INSTRUCTION TO SERVICE

ITS60624		February 2, 2023
SECTION:	241-Fuel System	
WRITTEN BY:	Aditya Gadepalli	
SUBJECT:	Fuel Vent Line Retrofit	
ISSUE:	MCI realized possibility of fuel splash back issues on Aluminum fuel tank without posilock filler neck	
SUMMARY:	Follow this procedure to install an additional vent line to eliminate the possibility of fuel splash back.

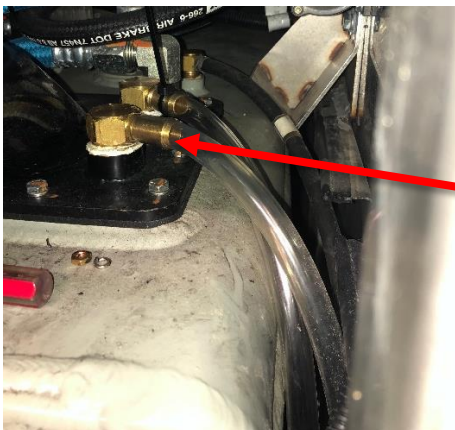
6. Remove and discard the blank plug next to vent valve.

Remove and discard the plug

7. Apply thread sealant, MCI P/N: 21-7203-2, to the vent valve, MCI P/N: 09-06-1708, and install it to the open port in the fuel tank.

Apply thread sealant and
install vent valve, 09-06-1708

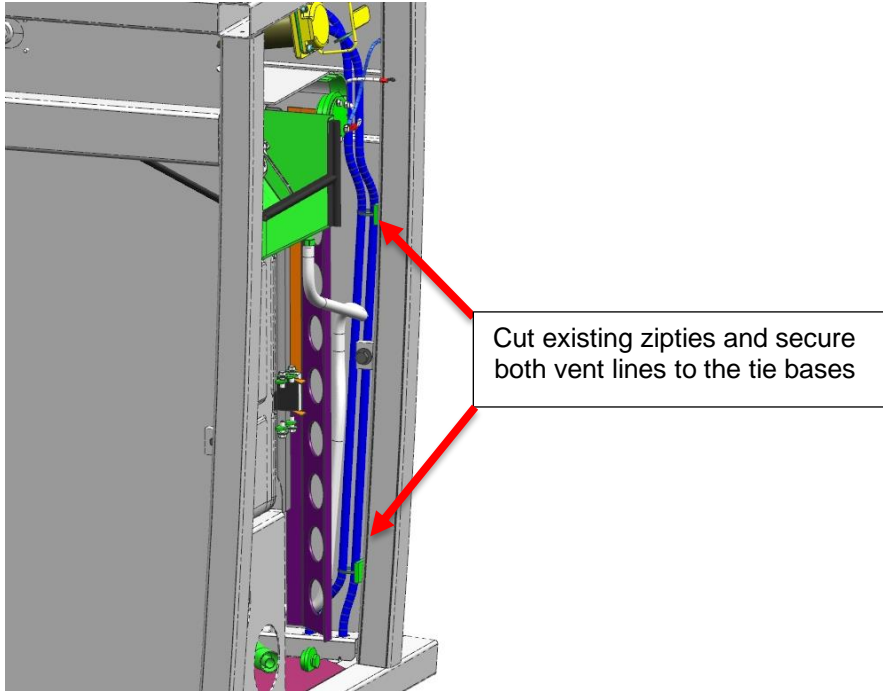
8. Cut 46" of the hose, MCI P/N: 06-14-1675, and install it to the new vent line using clamp, MCI P/N: 19-04-0384. Route it towards the floor along with the existing vent hose.

Install hose using
clamp, 19-04-0384

9. Cut the zipties securing the existing vent line and secure the two vent hoses to the existing tie bases using a zip ties, MCI P/N: 5958112.
